# UNITED STATES PATENT AND TRADEMARK OFFICE

10/582,666

<b>Office Action Summary</b>	<b>Application No.</b> 10/582,666	<b>Applicant(s)</b> AKIYAMA ET AL.	
	<b>Examiner</b> CLAIRE L. RADEMAKER	<b>Art Unit</b> 1795

The following illustration (modified Figure 3 of Bullock et al.) is provided for clarification:

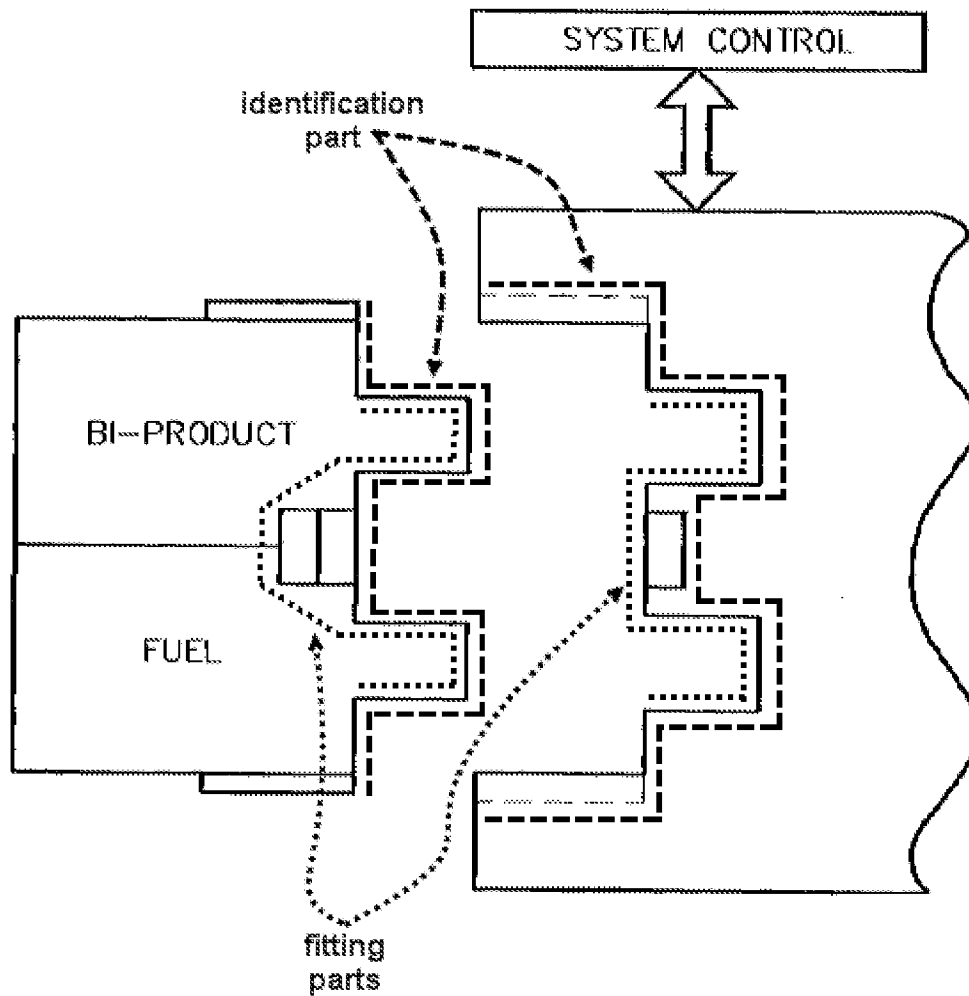
Claims 1-14 are rejected under 35 U.S.C. 102(b) as being anticipated by Bullock et al. (US 2003/0082416).

With regard to claims 1-14, Bullock et al. discloses a fuel cell / fuel cell device (208, paragraph [0055]; Figure 12) comprising:

a mounting part (140 & 146, paragraph [0028]; Figure 3) where a fuel cartridge (132, paragraphs [0026] & [0028]; Figure 3) filled with fuel is mounted in a detachable manner (paragraphs [0026] & [0035]),

an identification part that identifies the fuel cartridge to be mounted on said mounting part (148, 150, 152, 154, 156, & 158, paragraphs [0028] & [0030]; Figure 3), wherein said identification part includes:

a plurality of fitting parts (152, 154, 156, & 158, paragraphs [0028], [0033]-[0034]; Figure 3), where said fitting parts further comprise a detecting unit (200, 202a, & 202b, paragraphs [0028], [0033]-[0036]; Figure 3) that can detect whether the fitting part is fitted into a fuel cartridge or not (paragraphs [0028] & [0033]-[0036]),

selecting parts (148 & 150, paragraph [0028]; Figure 3) that make usable one fitting part to be selectively fitted into a specified cartridge among said plurality of fitting parts, and that can select one terminal connected electrically to a specified fuel cartridge from among said plurality of terminals (paragraphs [0028], [0037], & [0055]),

a judging part that judges the type of fuel filled in said fuel cartridge (200 & 126, paragraphs [0008] & [0039]-[0040]; Figure 3) based on the electrical connecting condition between said plurality of terminals and said fuel cartridge (paragraphs [0035]-[0036] & [0028]), and

a control unit (126, paragraphs [0025], [0035]-[0036], & [0041]; Figure 3) that controls the operation condition depending on the type of fuel judged by said judging part (paragraphs [0008], [0025], [0035]-[0036], [0039]-[0040]; Figure 7),
